ADDENDUM NO. 7
NEW SOFTBALL COMPLEX FOR TRUSSVILLE CITY SCHOOLS
Architect Job No. 23-72
April 23, 2024
DCM # 20240224

NEW SOFTBALL COMPLEX FOR
TRUSSVILLE CITY SCHOOLS
6344 HUSKY PARKWAY, TRUSSVILLE, AL 35173
TRUSSVILLE CITY BOARD OF EDUCATION

SHEET TITLE:
JCES PLAN & PROFILE

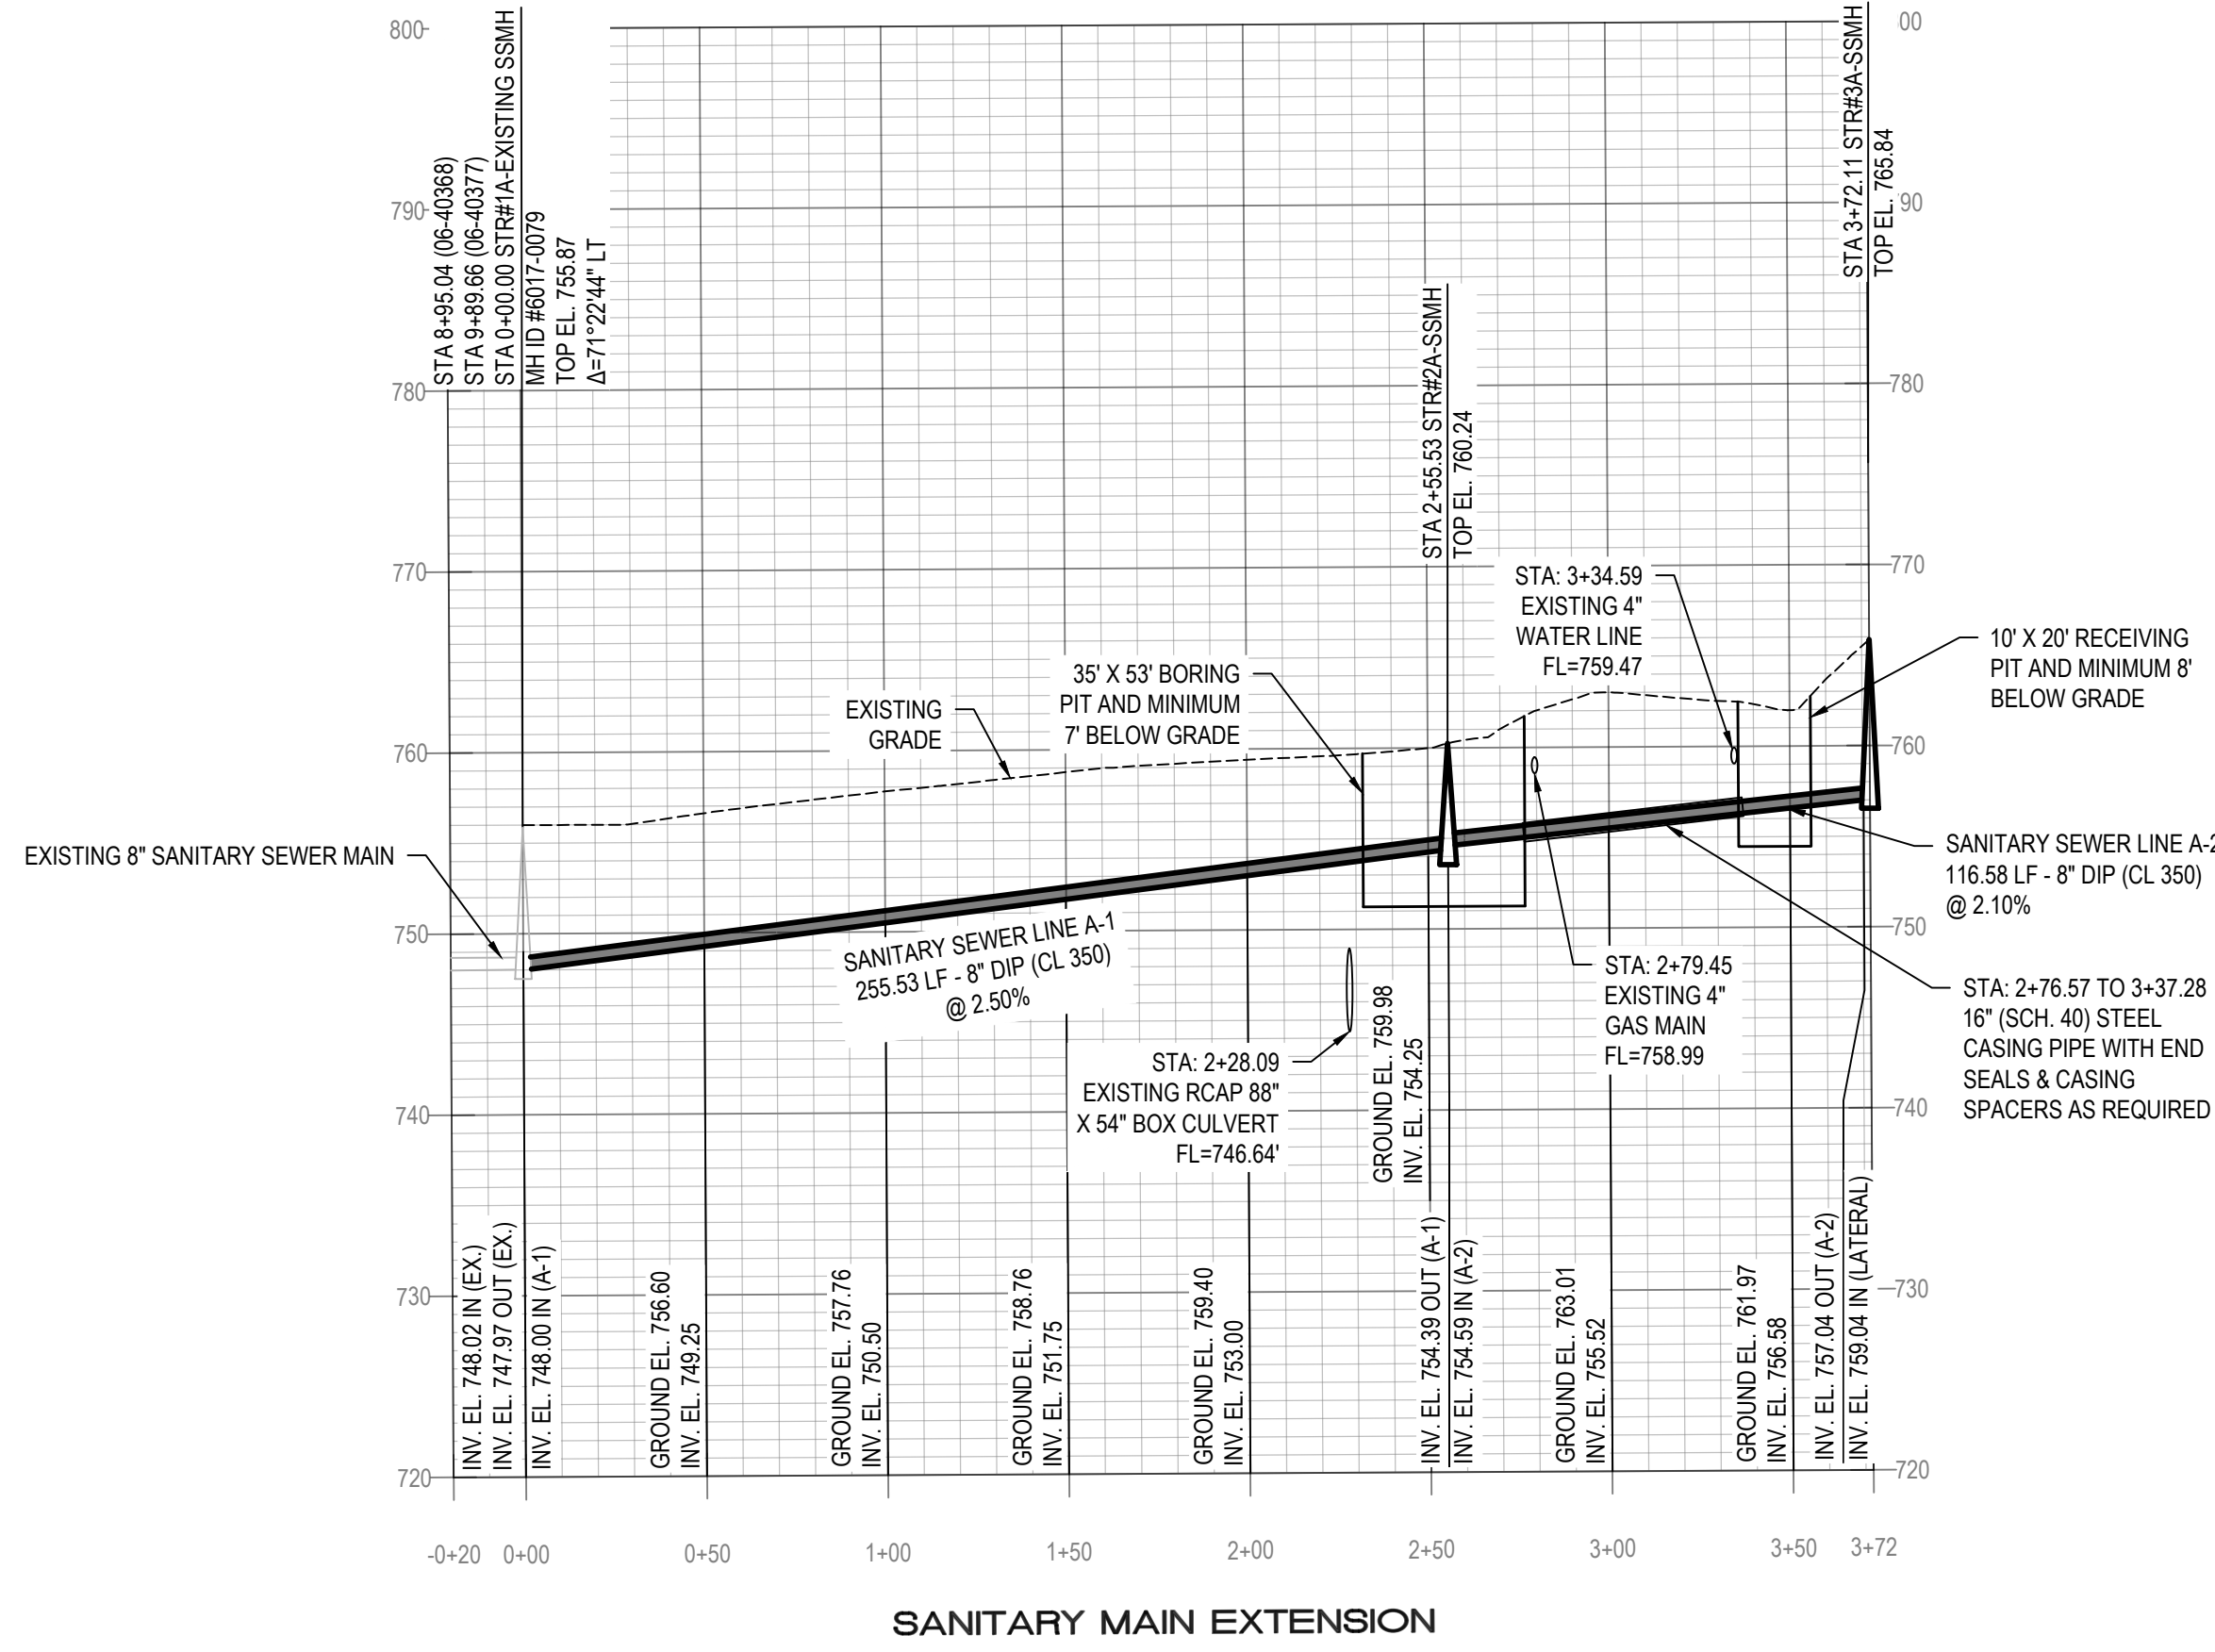
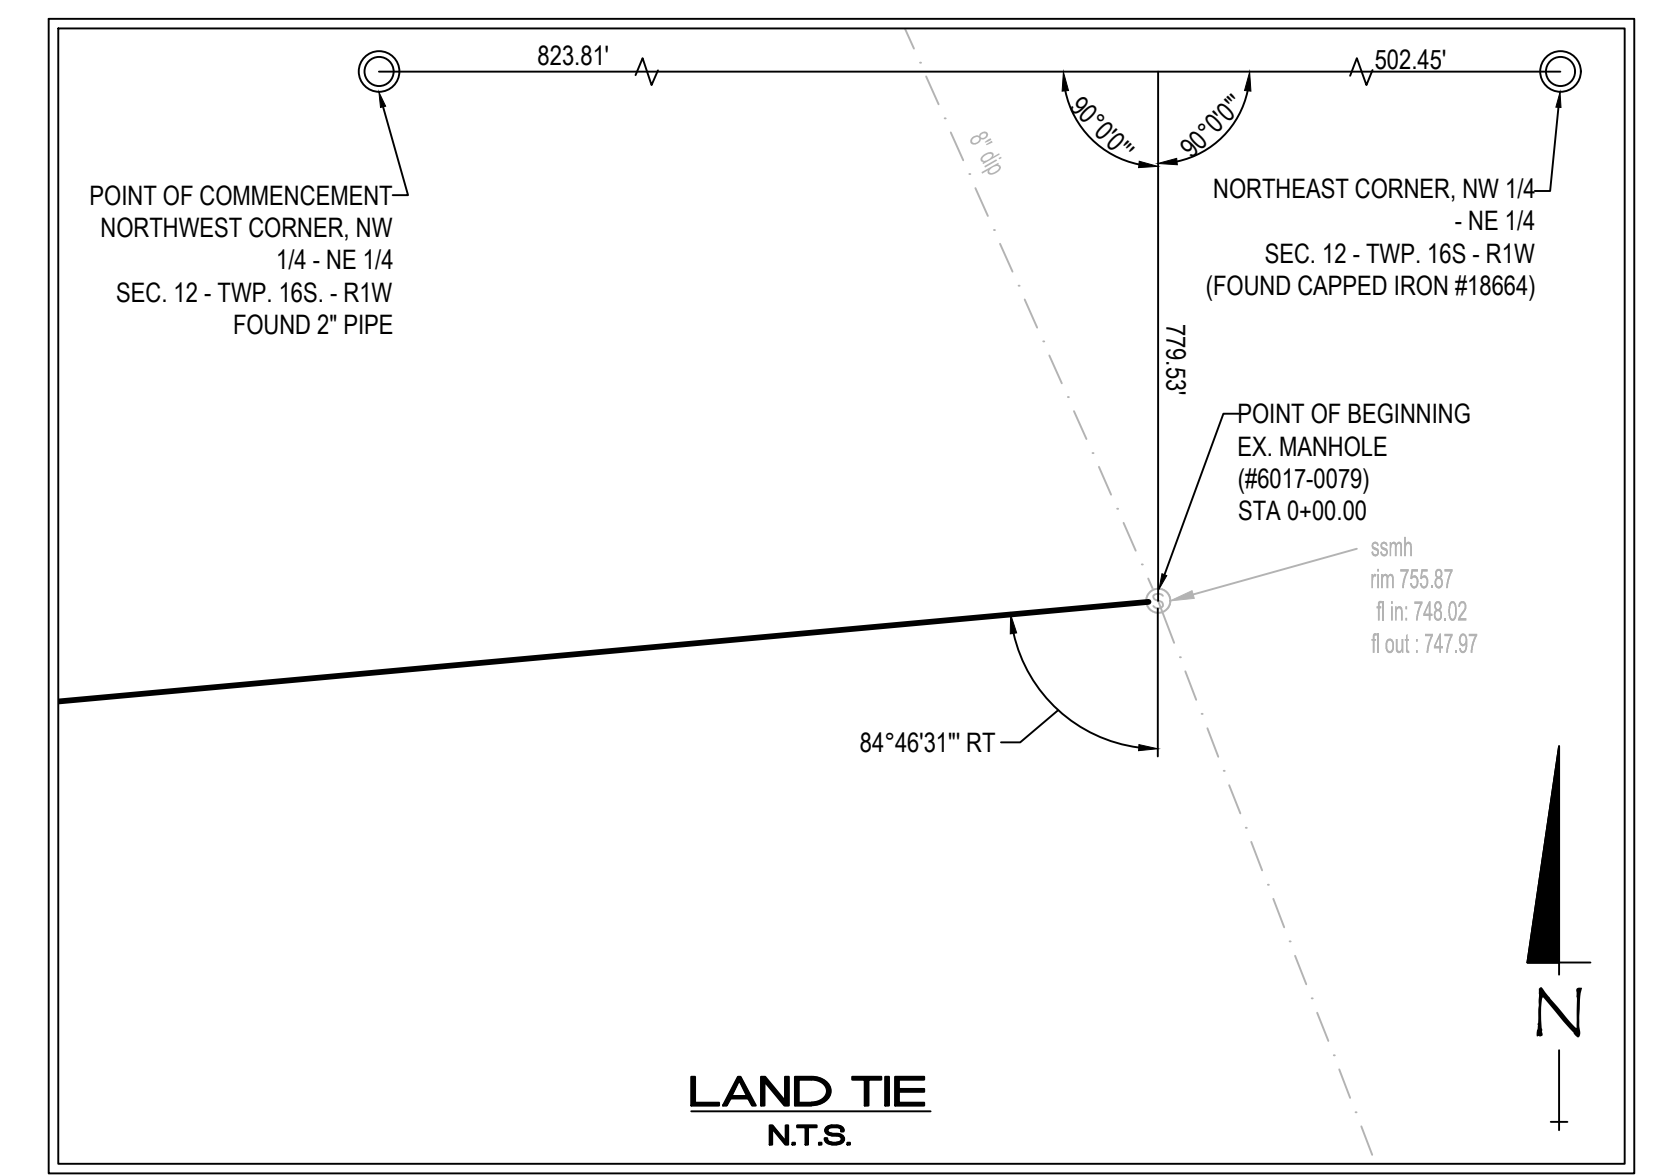
1. See attached Sheet **C5.1** for revisions to JCES Plan & Profile.
2. See attached Sheet **SP1.0** – Layout and Material Plan **REVISED TO ADD** the following Field Equipment Notes:

JOB NO. **23-72**
SHEET NO. **SP1.0**

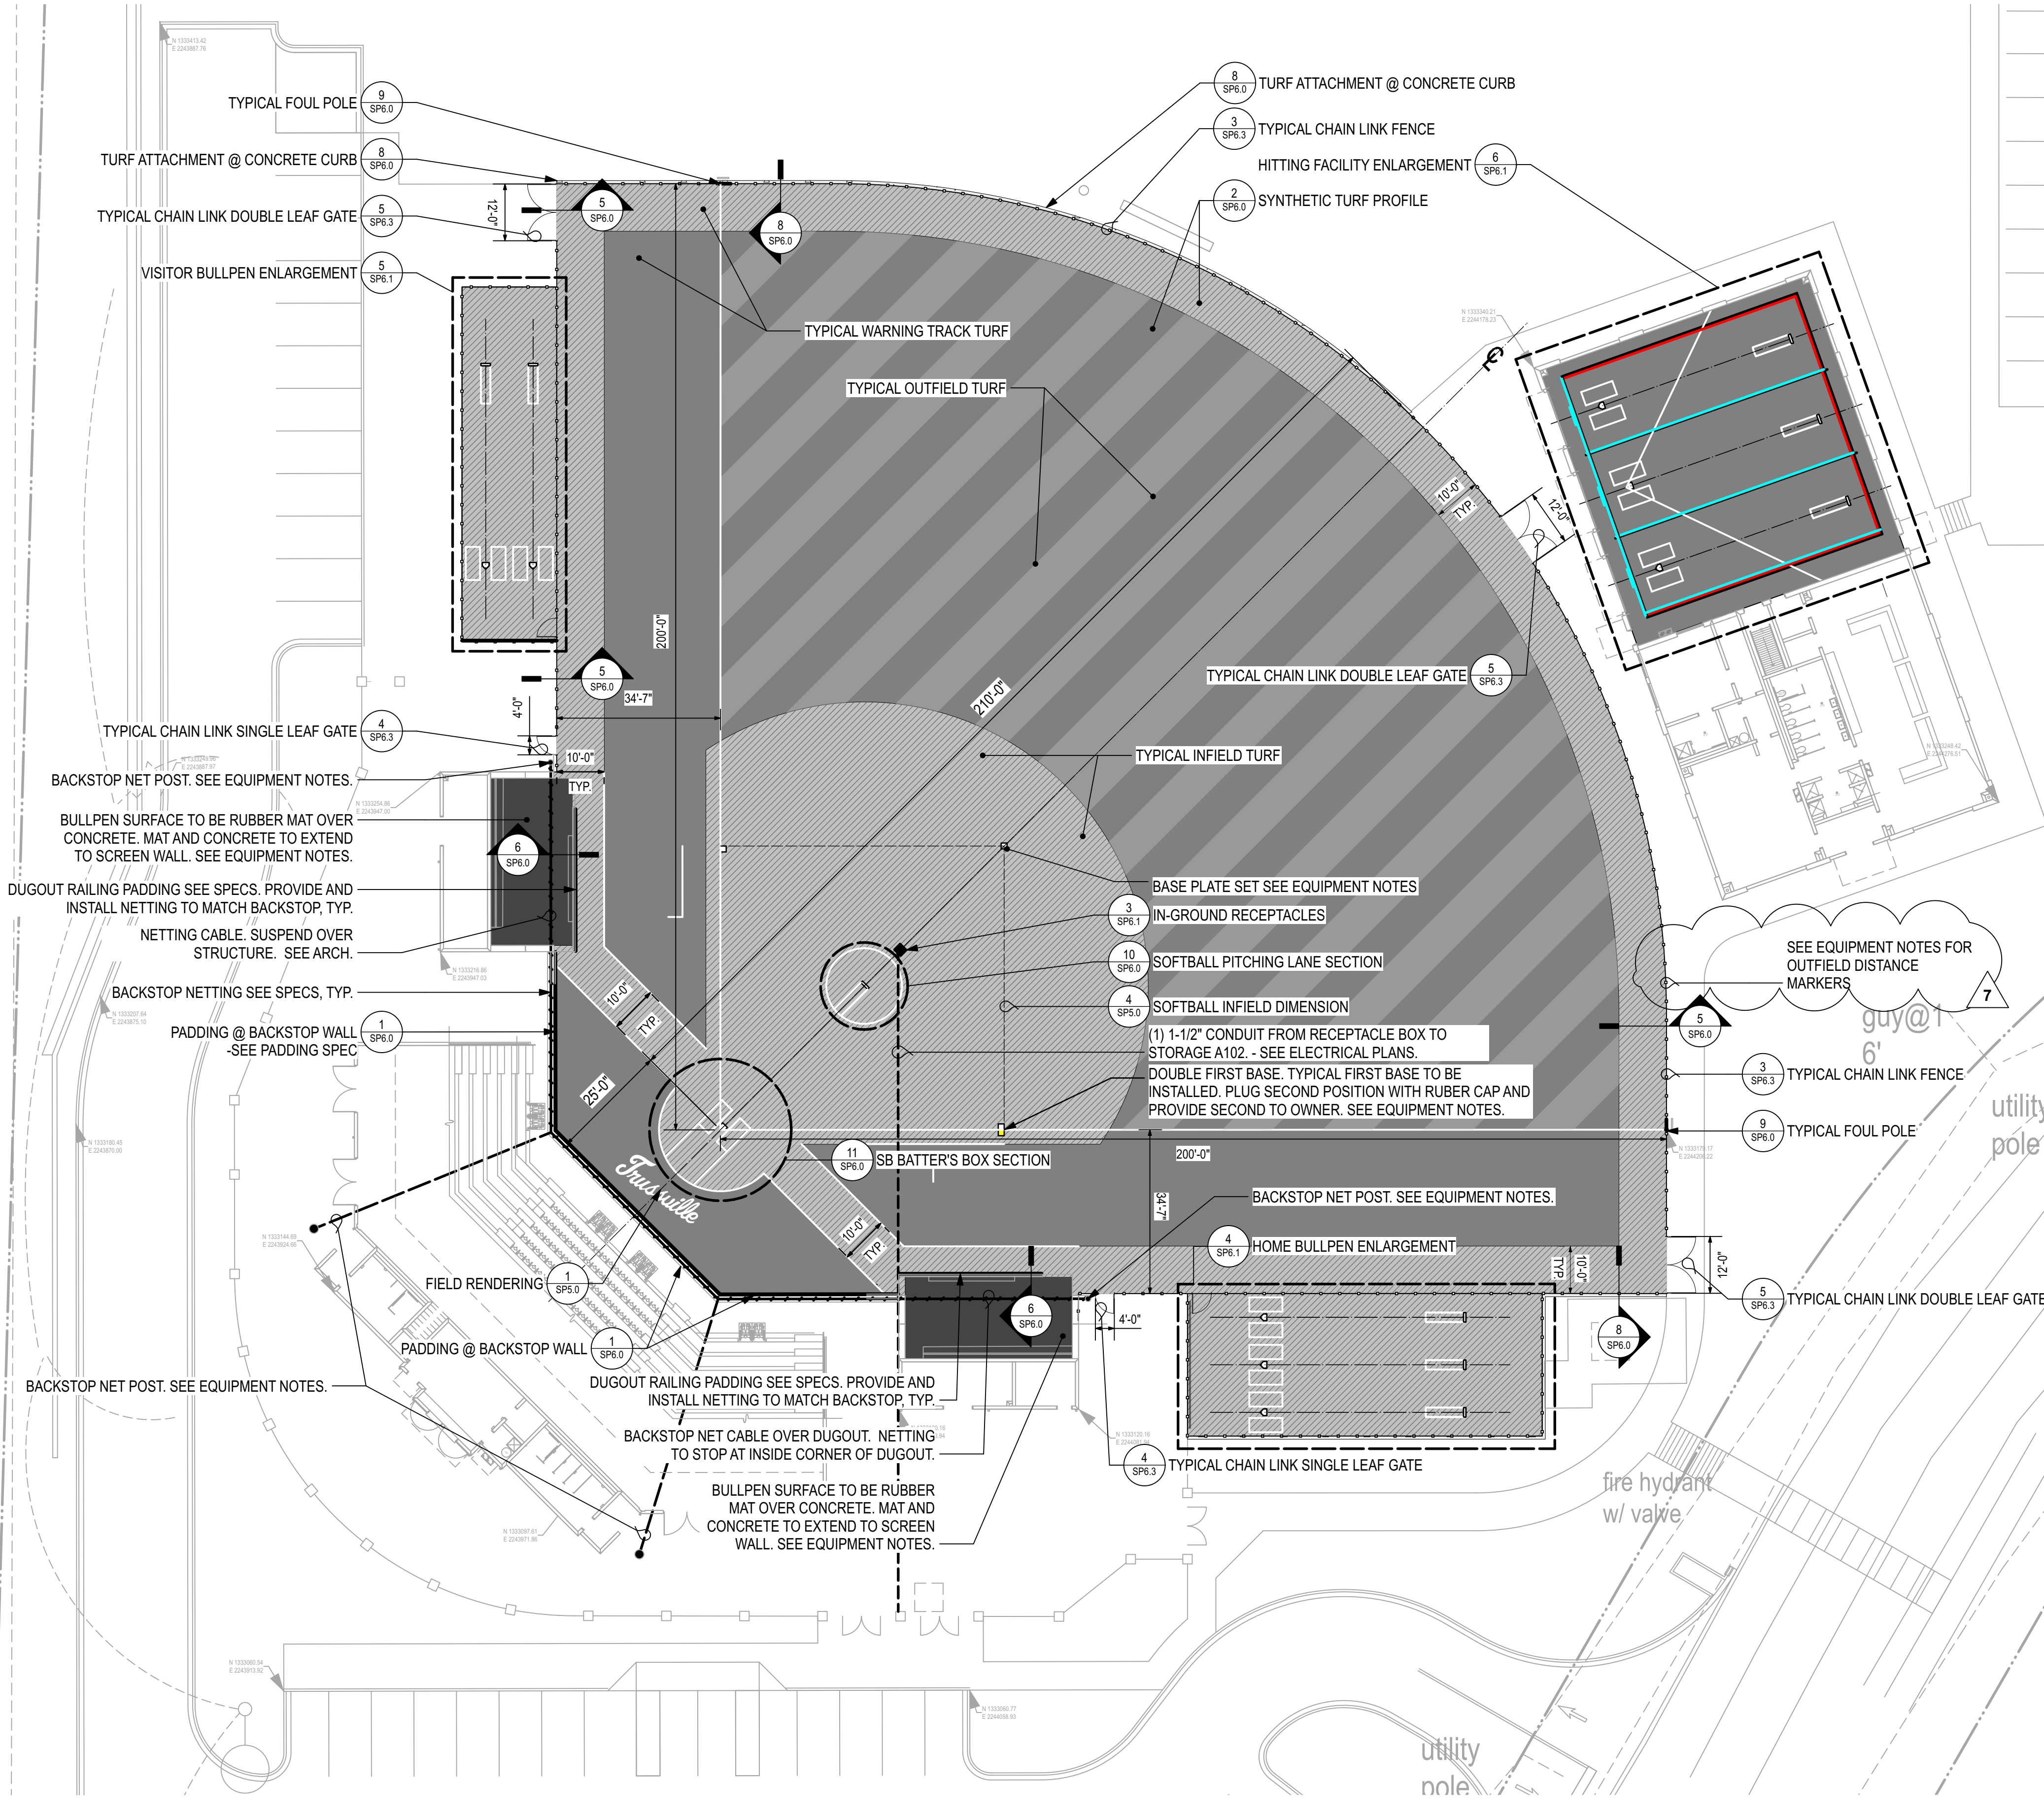
“14. **OUTFIELD DISTANCE MARKERS (VINYL LETTERS, PLASTIC PANEL, ZIP-TIED TO FENCE, LF, CF, RF).**”
3. See attached Sheet **SP6.1** – DETAILS revised Detail 3 “IN-GROUND RECEPTACLES”.
4. See attached Sheet **SP6.2** – DETAILS revised Detail 3 “PLYOWALL MAT-BACK”.

- OUTFIELD DISTANCE MARKERS (VINYL LETTERS, PLASTIC PANEL, ZIP-TIED TO FENCE, LF, CF, RF)
